HUNTERS RIDGE BUILDING -B

Pasco County Florida
REVIEWED FOR CODE COMPLIANCE
Approval of these documents constitutes
authority to proceed with the work but does not
grant authority to violate, cancel, alter or set
aside any of the technical codes

COVER SHEET BUILDING - B

HUNTERS RIDGE
NEW PORT RICHEY

QUAIL ELECTRICAL PLAN SALE 3/16" = 1'-0" A.E.C.S. 16022 QUAIL & ELK MODELS

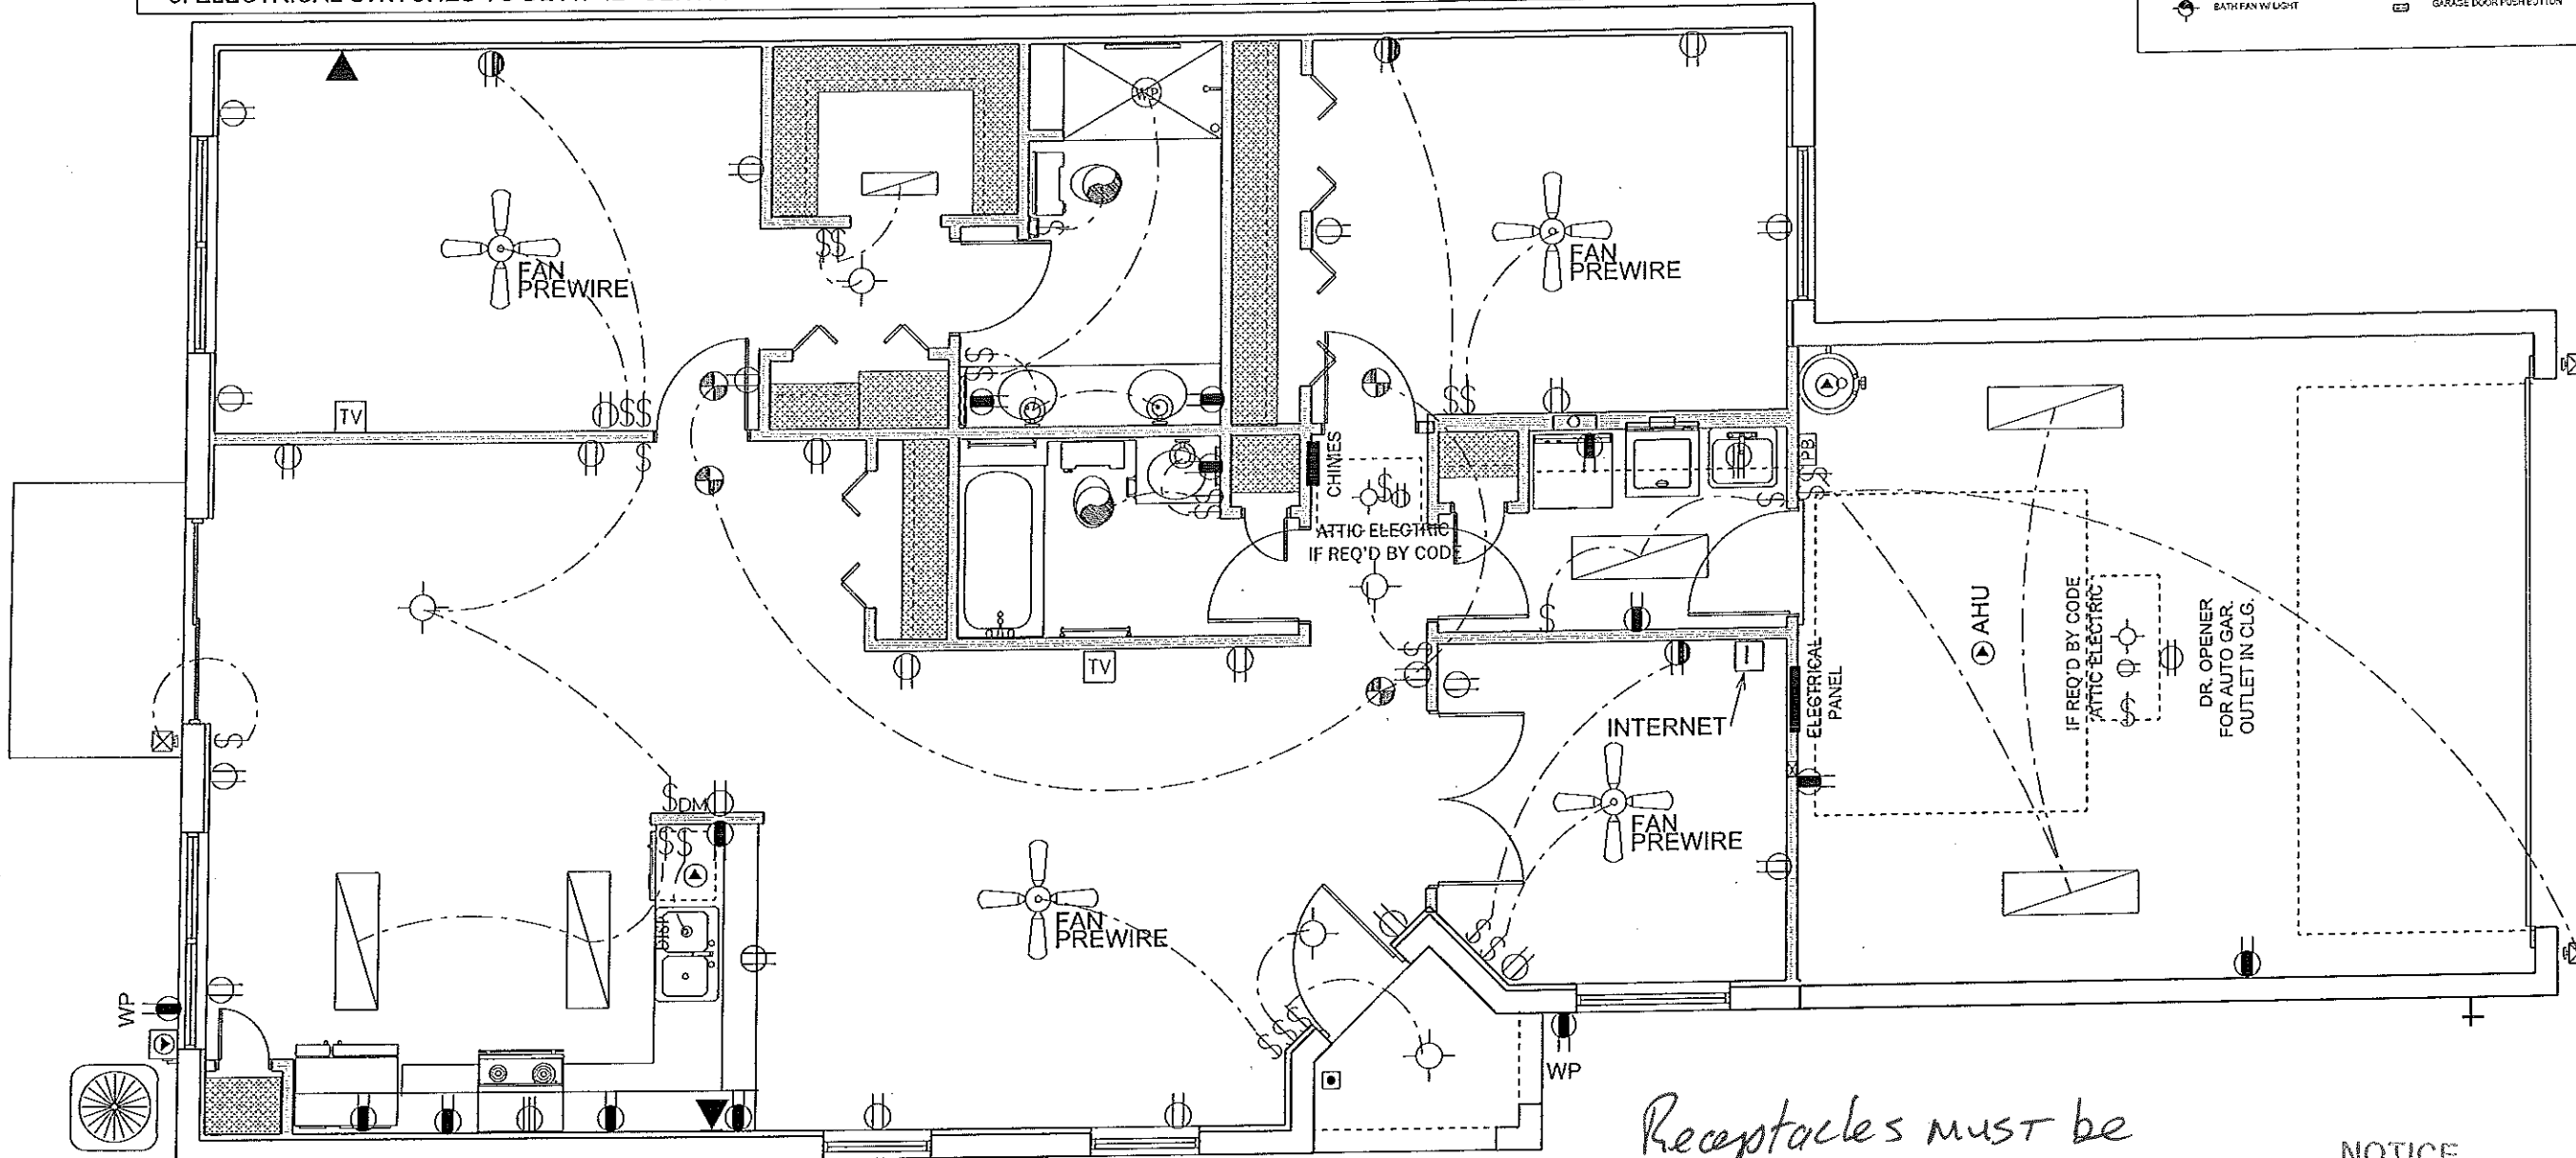
Receptacles must be spaced to code

210.52

QUAIL - Mechanical
 FLOOR PLAN NOTES

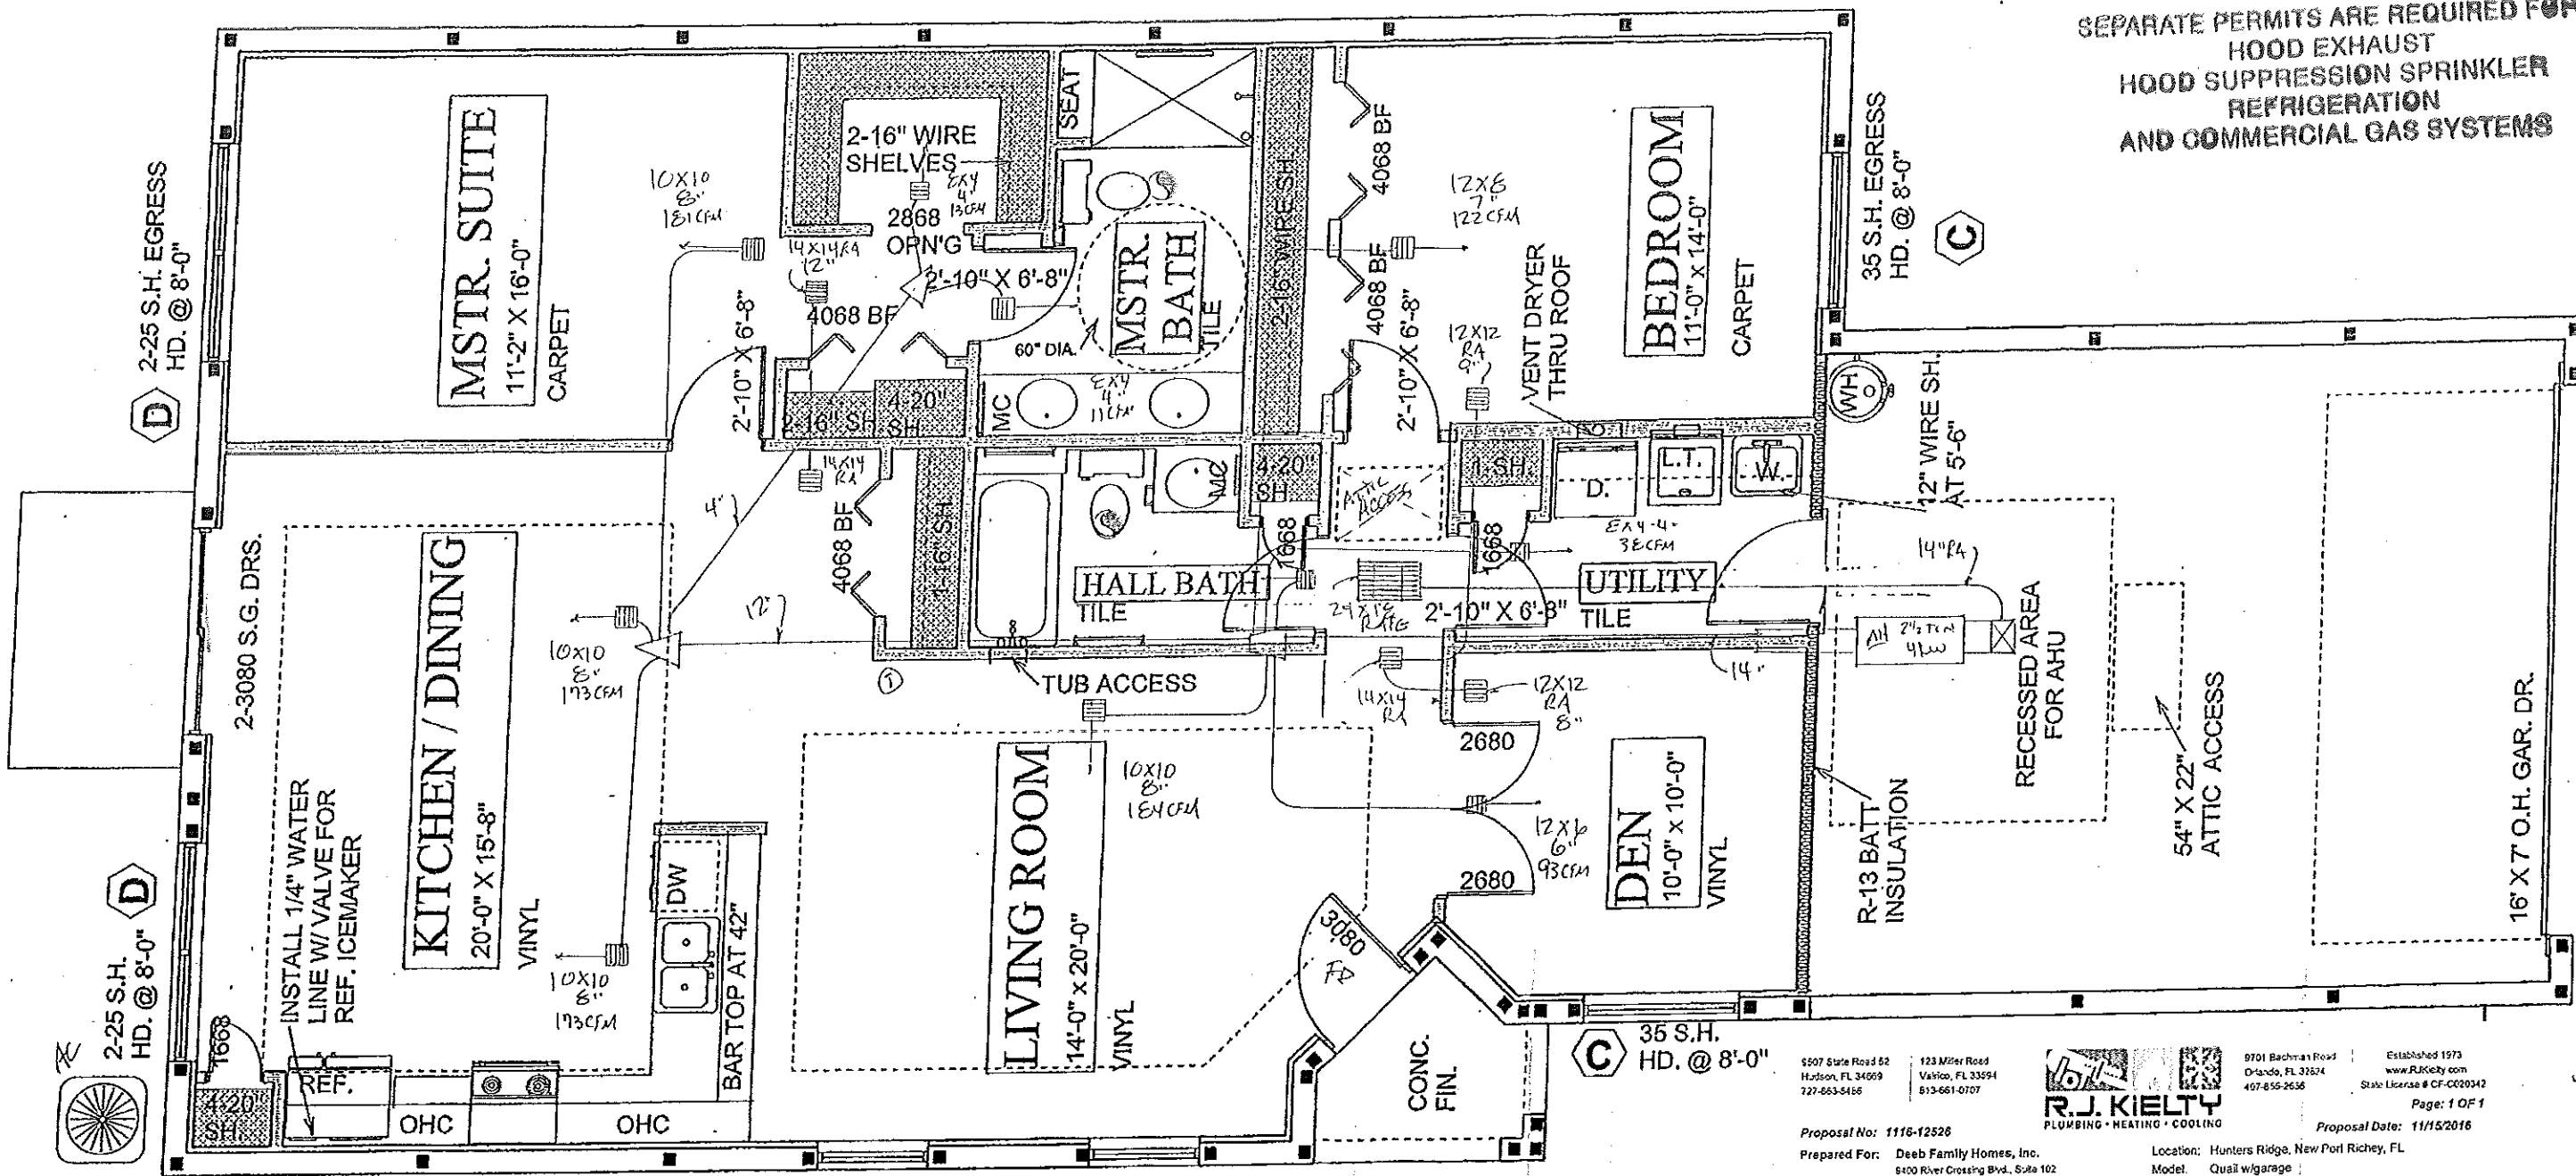
All mechanical curbs, stands or other supports that require engineered anchoring must be inspected before covering.

Smoke or fire dampers required if ceilings or walls are rated.
